**OFFICIAL COORDINATION REQUEST  
FOR NON-ROUTINE OPERATIONS AND MAINTENANCE**

**COORDINATION TITLE- 17TDA09 AWS Steel Frame**

**COORDINATION DATE- Mar 13, 2017**

**PROJECT- The Dalles Dam**

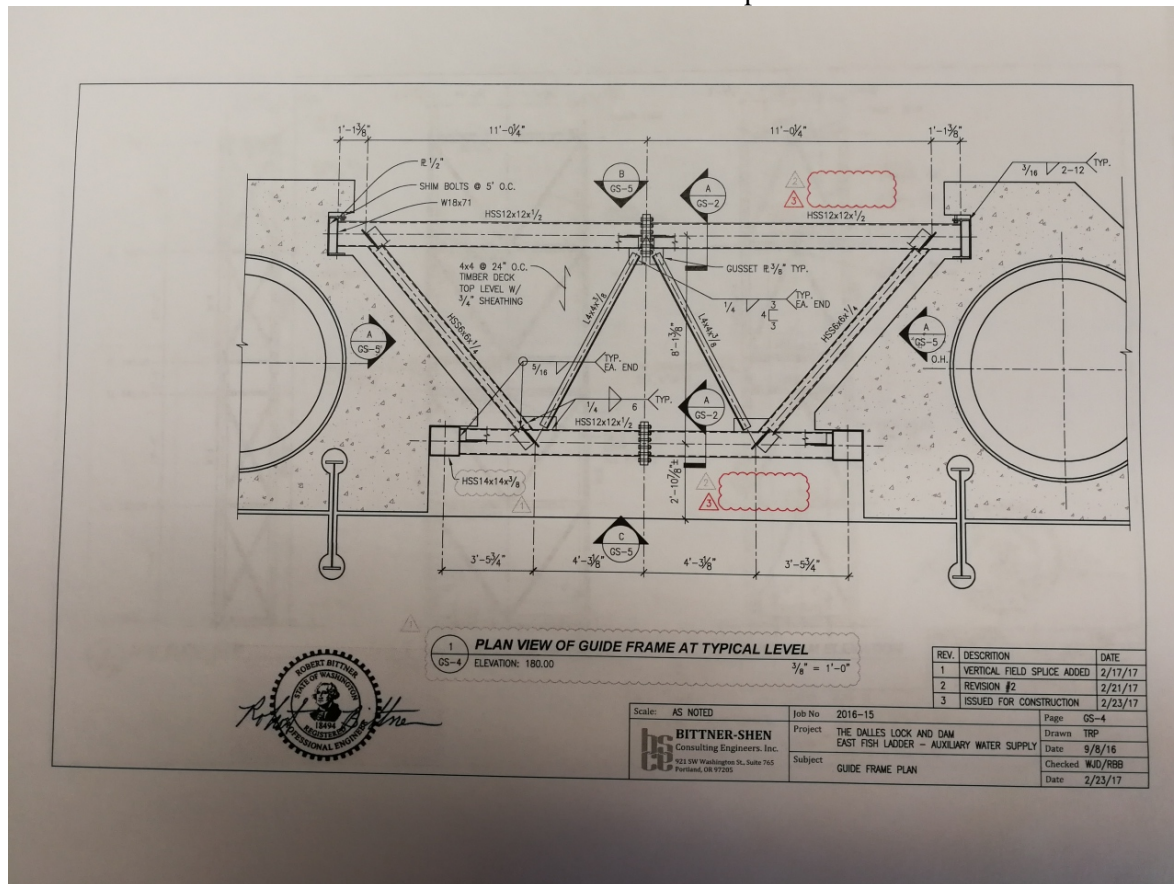
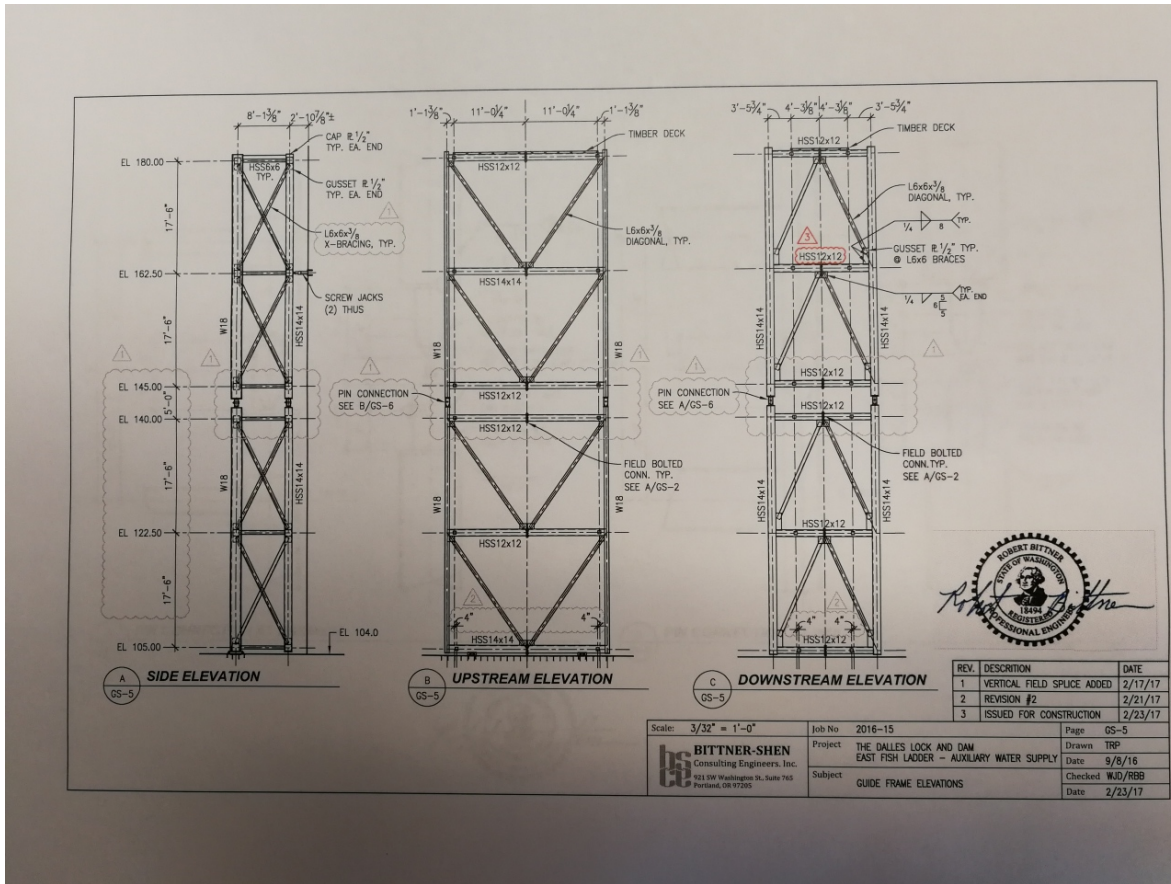
Erin/Bob, After thinking about this one for a bit and looking at the Plans and Specs, I can see that the footprint of this thing really isn't any larger than the finished intake, so no problems with having it in place all season. What concerns me is the work activity and proximity to the ladder exit. What I would like to see is more information regarding contaminants from the construction work (solvents, paint, curing agents, welding byproducts, etc.) that might be pulled into the fishway and possibly effect fish holding overnight in the ladder and collection channel. Thanks, Gary

looked this over at the meeting, seems with the work done at night should not pose a big issue.
